# MLC SIGNIFICANCE

# HERITAGE NSW REVIEW

# HERITAGE NSW REVIEW - SCENARIO 3

Figure 4. Comparison MLC North Sydney Floorplate with Lever House, New York (coloured orange)

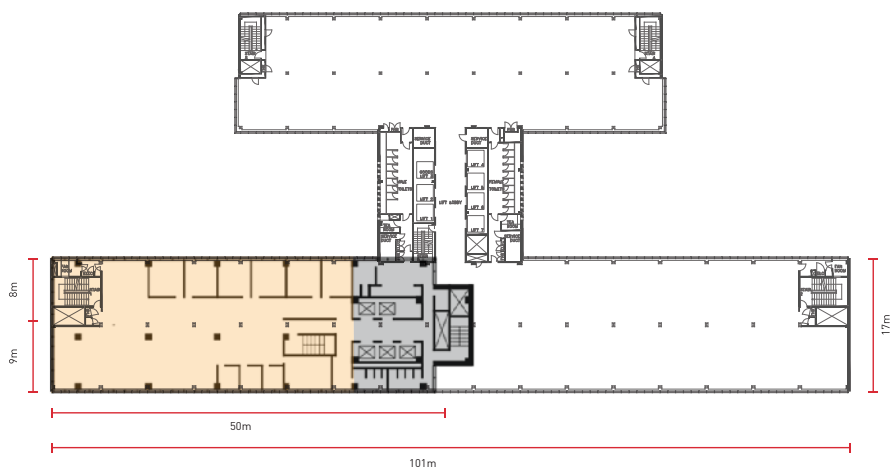
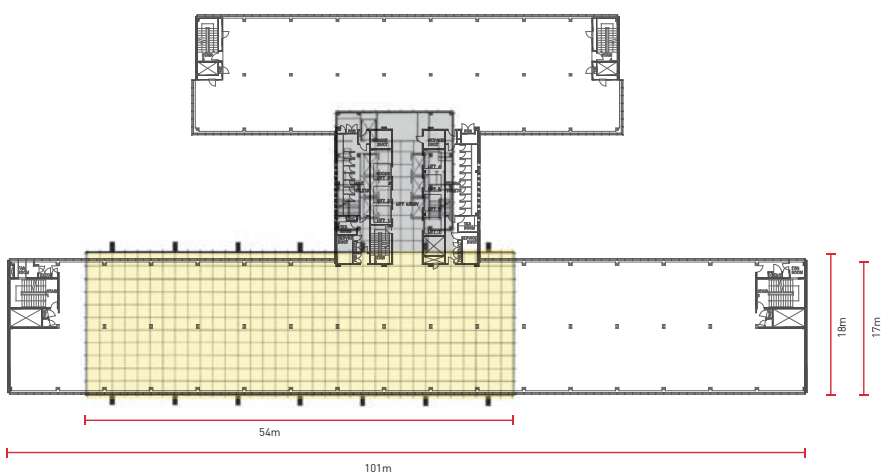
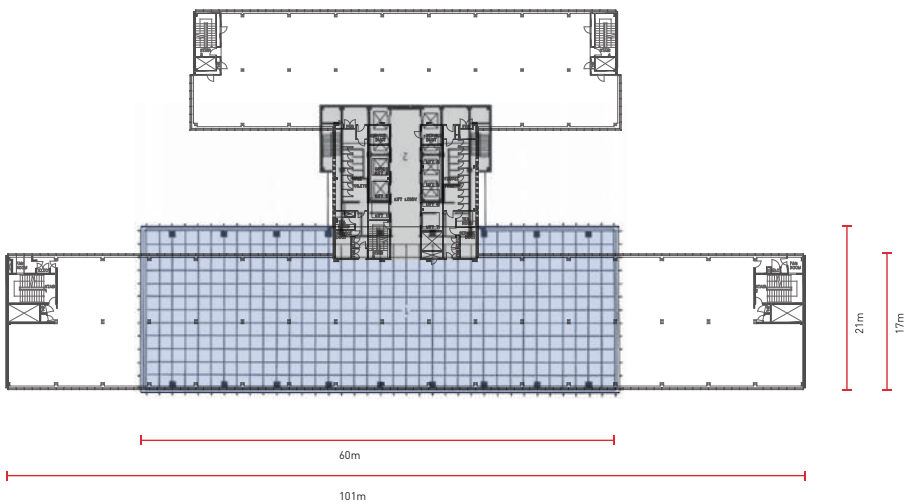
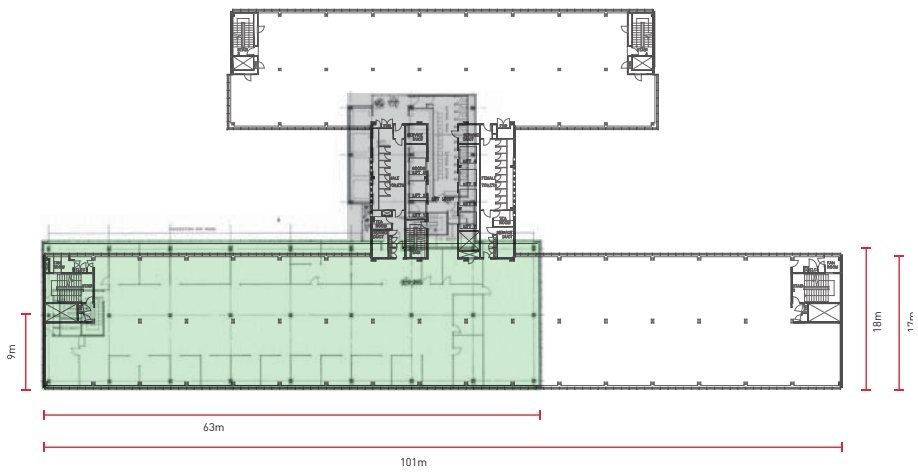
*The comparative analysis of similar floorplates clearly demonstrates that MLC building is **challenged in being substantially longer** (circa 100m) than all relevant comparisons. This is not addressed by the Heritage NSW review and in fact supports our assertions of it’s commercial leasing challenges.*

Figure 10. Three 500 m² tenancies MLC North Sydney Floorplate (Miller Street wing) using furniture layouts from Sydney 2020 Competition entry

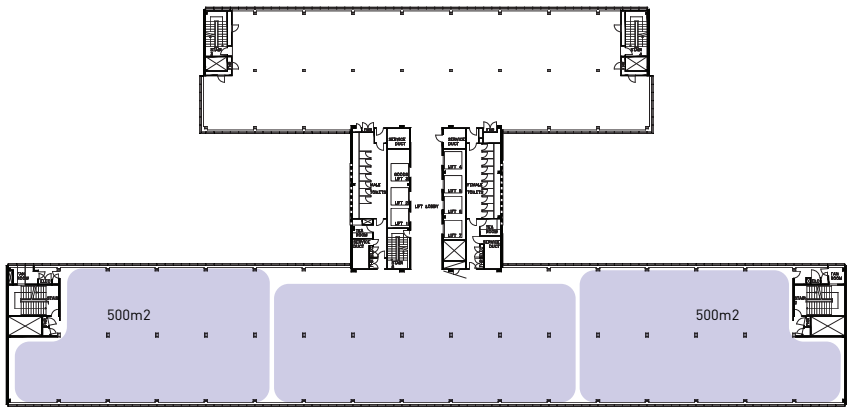
*Tenancy layout comparisons re-arrange  
MLC layout but **ignore the building  
length issue***

Figure 17. Indicative 3D Massing Diagram of Scenario 3 viewed from the west

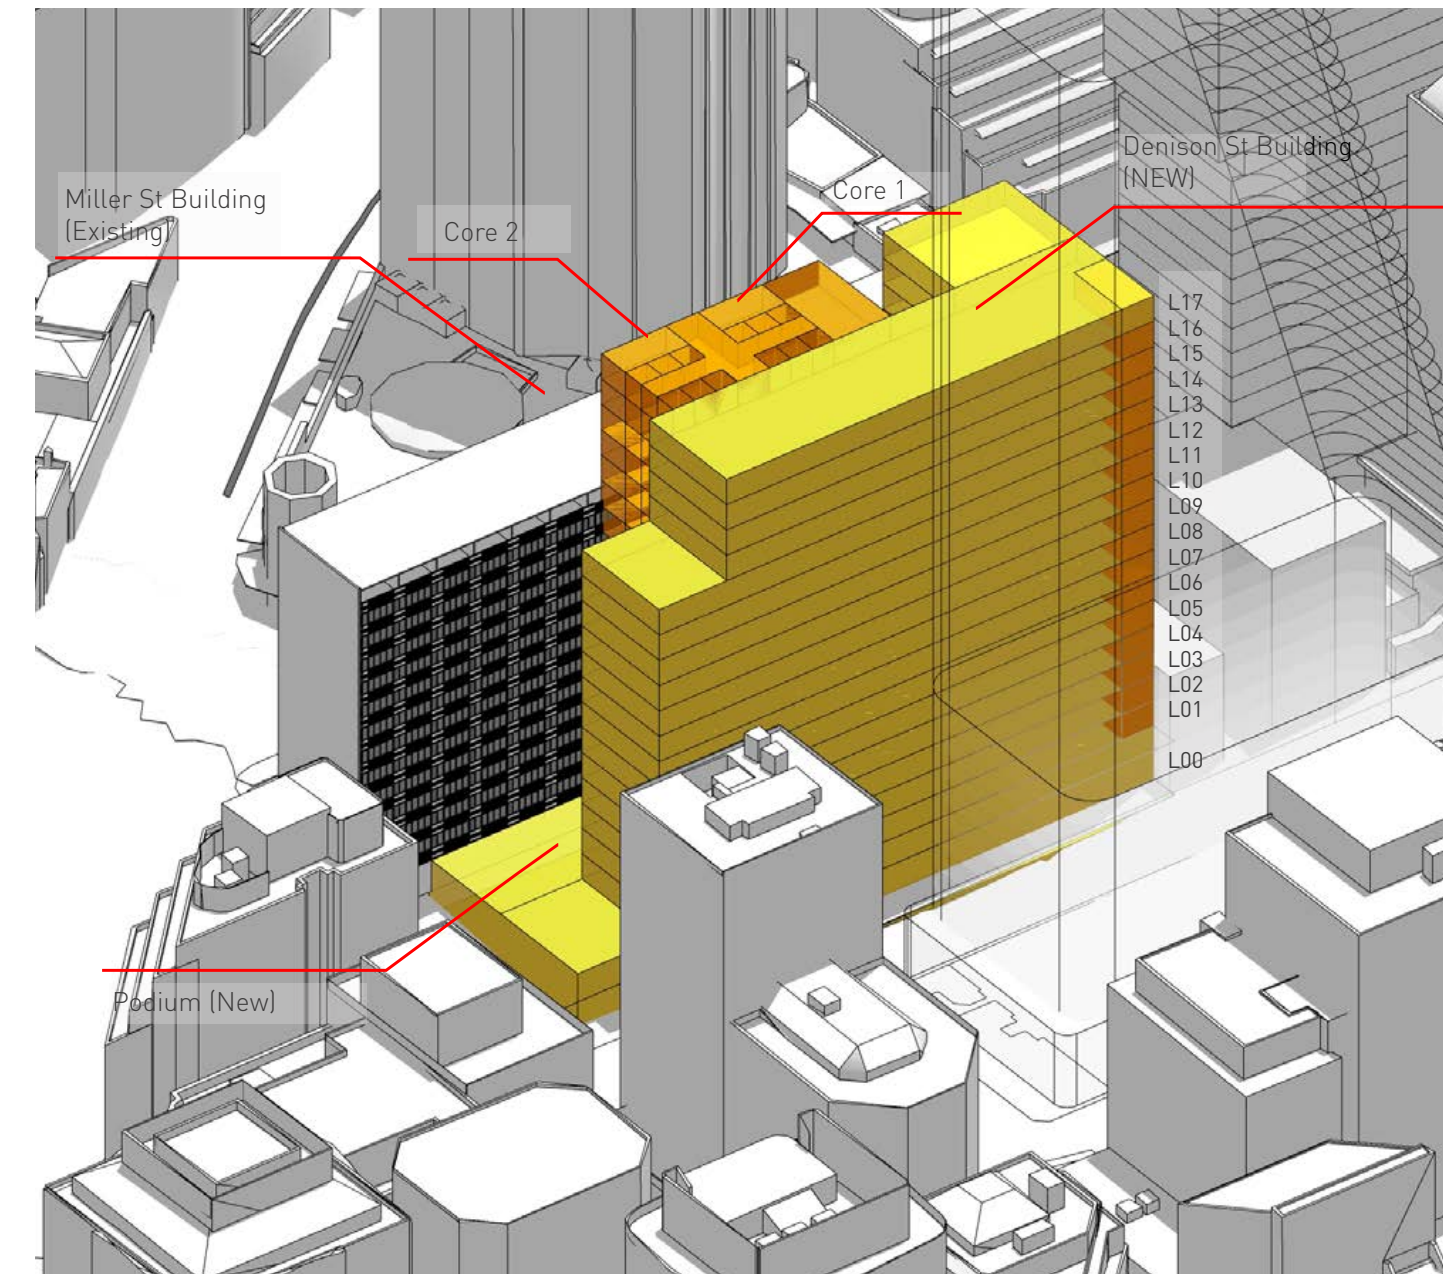
*No allowance for rooftop plant*

*No allowance for lift overrun*

*Does not deal with existing floor-to-floor heights*

*Unsympathetic relationship with the western MLC Wing*

Figure 23. Shadow Diagrams for Scenario 3 - 18 Levels (L00 + 17)  
Diagrams based on current conditions.

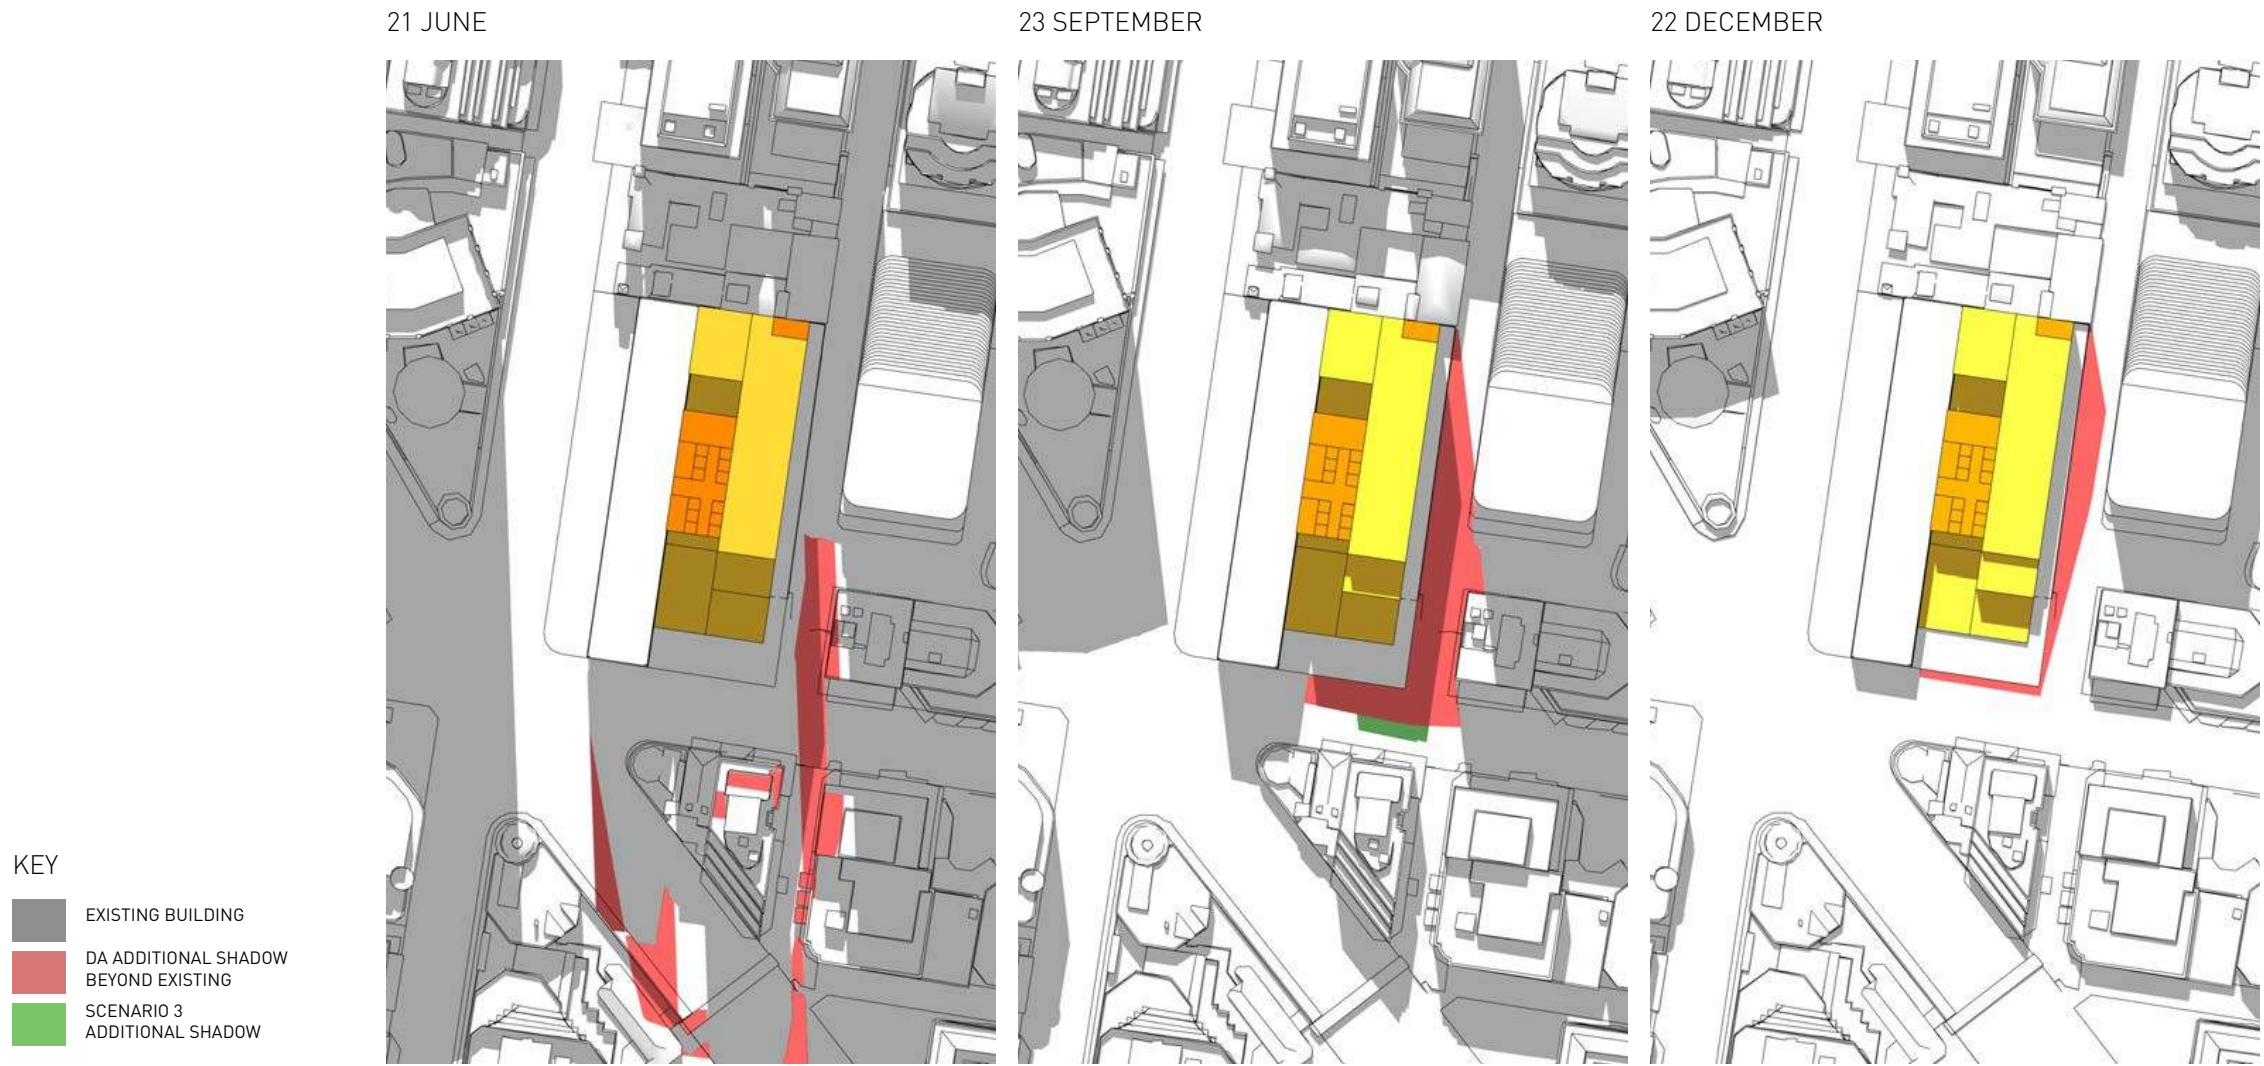
***Scenario 3 significantly increases overshadowing of Brett Whitely Place as shown in the Heritage NSW Report.***

A new eastern wing of the MLC North Sydney would add a small amount of extra shadow beyond the DA proposal (shown in green) on Brett Whiteley Place at the equinox (23 September)
